Service Bulletin

PRELIMINARY INFORMATION

Subject: Warm Air Exhausting from Driver and/or Passenger Front Seat Back into 2nd Row Seating Area Causing Occupant Discomfort

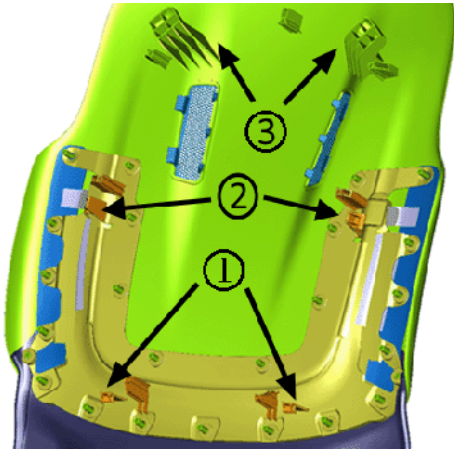
Some customers may comment on warm air exhausting from the driver/passenger front seat back into the 2nd row seating area, causing occupant discomfort.

The cause of this condition may be that during cooled seat operation, a direct flow of warm air exhausts from the upper seat back ventilation heating/cooling blower thermal exchange blower unit.

It has been found that removal of the exhaust duct (1) on the upper seat back ventilation blower allows for a less direct air exhaust and disperses the warm air more thoroughly within the seat back cushion. Remove the upper ventilation blower duct from BOTH the driver and passenger seats using the following steps:

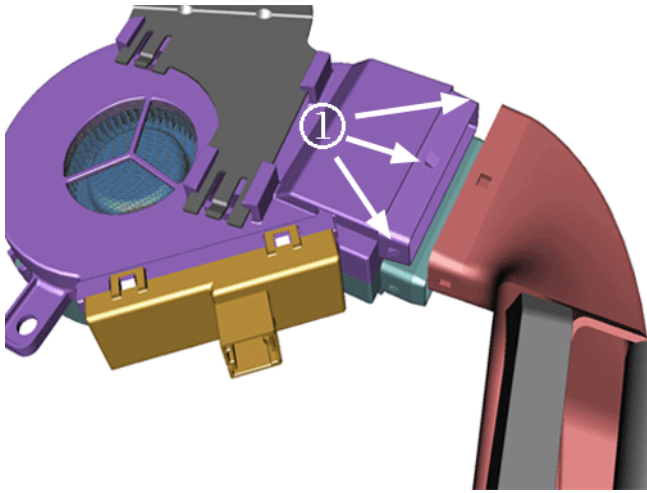
Caution: To help avoid damage to the seat back finish panel, after detaching the lower bungee clips, carefully reach behind the finish panel from the bottom to locate the flat of the lower retainer hooks (1). While pushing up on the flat of the hook, push inward on the panel in the area of the hook to release. Once the lower retainers are released, pull down on the back panel to disengage the upper rigid retainer hooks (3). Detach the side retainer hooks (2) by pushing inward and toward the center of the seat, one side at a time.

1. Starting on the driver or passenger front seat, remove the front seat back cushion finish panel. Refer to *Front Seat Back Cushion Finish Panel Replacement* in SI.

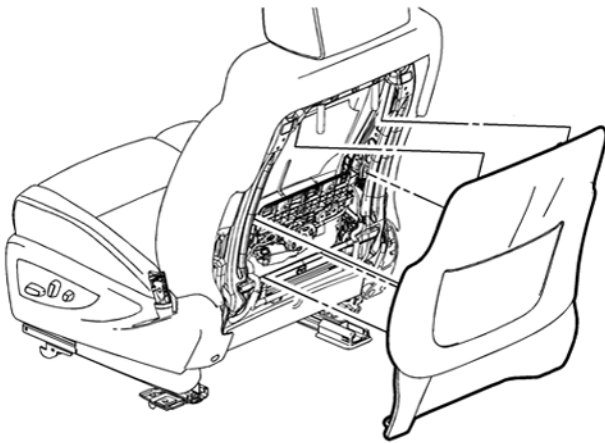
2. Locate the ventilation blower exhaust duct. Depending on the vehicle, the duct may look like either example shown in the graphic above.

- Grab and twist the ventilation duct to release the top and side retaining tabs (1), and remove the duct from the vehicle.
